FINAL
NAVAL AIR STATION ALAMEDA RESTORATION ADVISORY BOARD
MEETING SUMMARY

September 04, 2008

PROPOSED REMEDIAL DESIGN AND REMEDIAL ACTION SITE 1

AREA 1b - IMPLEMENTATION

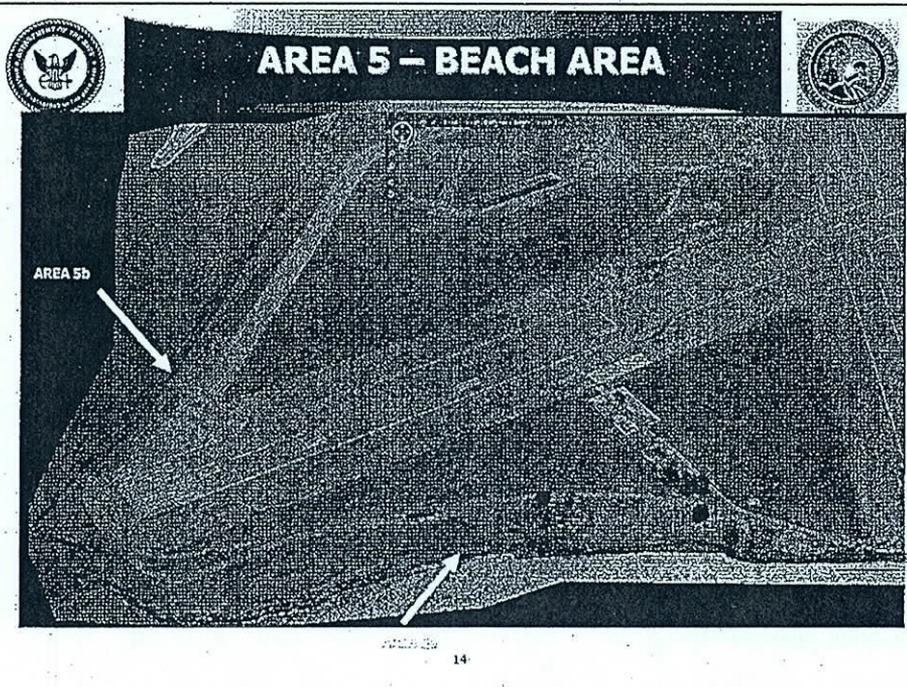
The remedial plan for Area 1b (burn area) is excavation, characterization of waste for proper disposal, and backfilling per the seismic design. During implementation (Slide 13), an in situ radiological (RAD) screening pad will be set up. Soil areas hot with RAD activity, identified by a drive-over scan, will be removed with an additional 1 foot of soil and transported to a secondary RAD screening. RAD items would be taken to the intermodal radioactive bin and RAD disposal area. Mr. Hoffman asked if anything other than RAD would be screened, and Mr. Robinson said that other chemical constituents will be evaluated. Mr. Hoffman asked if excavation would continue to the depth of the water table and whether water samples would be collected. Mr. Robinson said that the current proposed plan includes excavation to the water table, which is 3 to 7 feet below ground surface (bgs) at Site 1, but water samples would not be collected. Mr. Hoffman commented that it would be a good opportunity to collect water samples because the area is downgradient of the waste cells.

GROUNDWATER VOC PLUME PLANNING

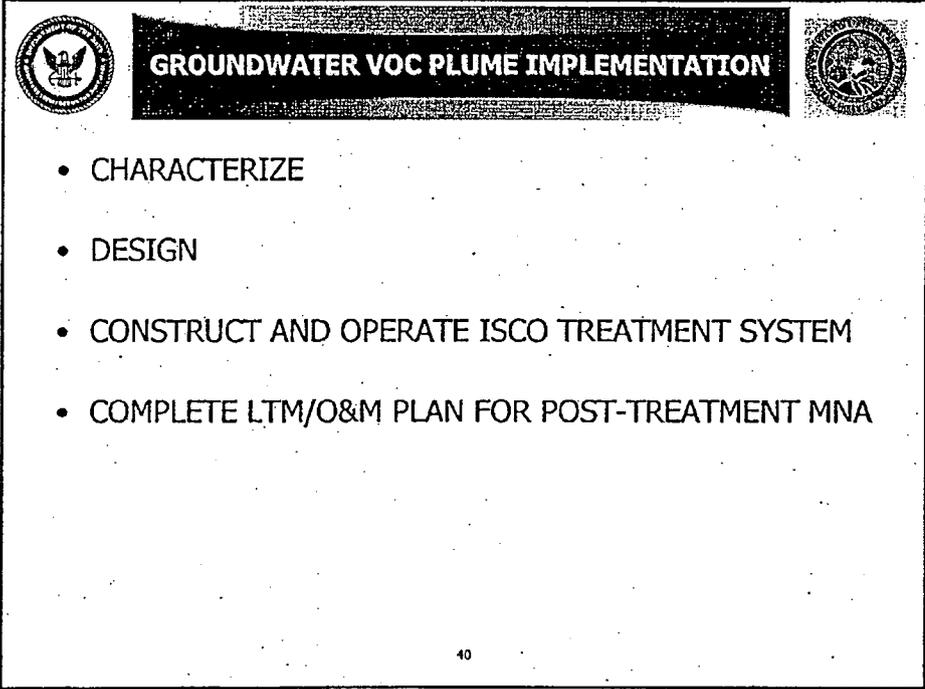
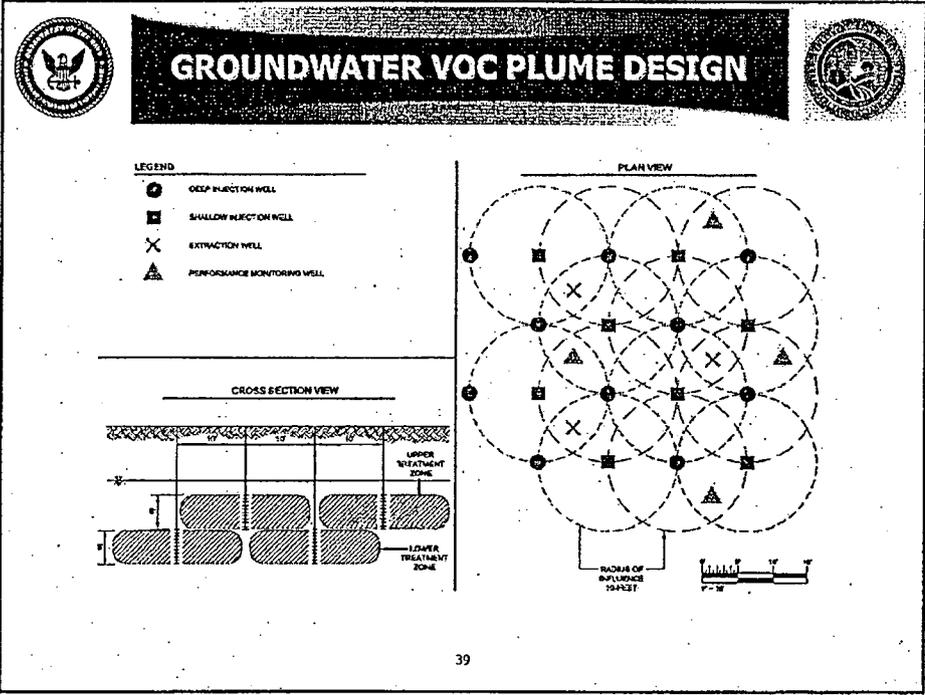
Mr. Robinson explained the general VOC plume design (Slide 39). Mrs. Sweeney stated that the wells would be injected after the soil cover was installed, and Mr. Robinson confirmed her statement. Mr. Humphreys said that there are some extraction wells at the edge of the bay about 30 to 40 feet from the shoreline. Mr. Robinson replied that plume migration will be considered and mitigated, if necessary.
